AIRAC AMDT 01/26

**VILNIUS (EYVI)
RNAV RMY 01**
ATMEZ 1A, DUKAT 1A, ELEKA 1A,
LAFAT 1A, SOGBI 1A, UPASI 1A

EYVI AD 2.24-10-1

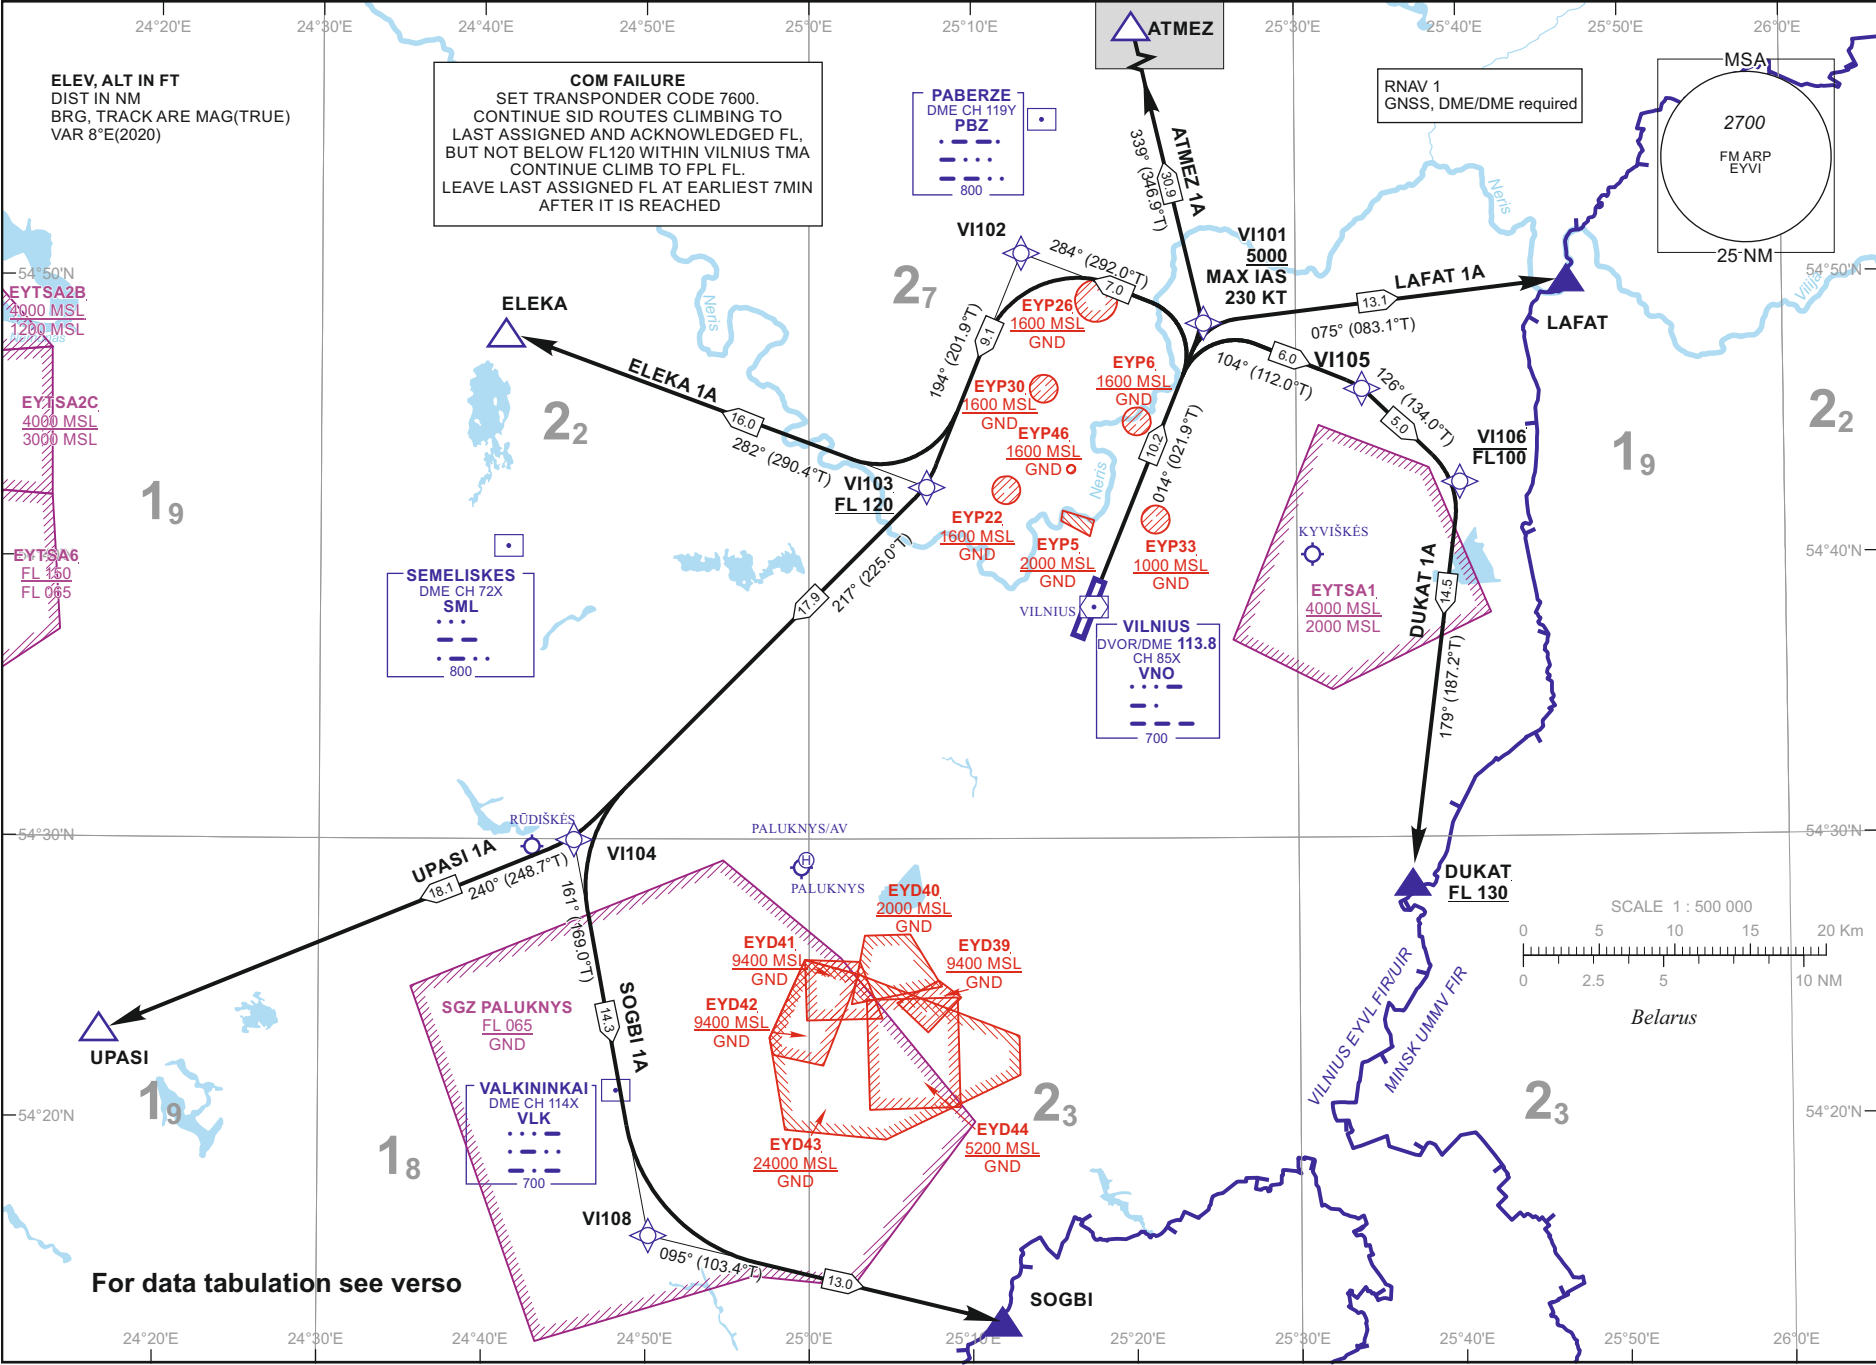
Changes: SID TAGOL 1A and EYP45 withdrawn; SID ATMEZ 1A and EYP46 added; note.
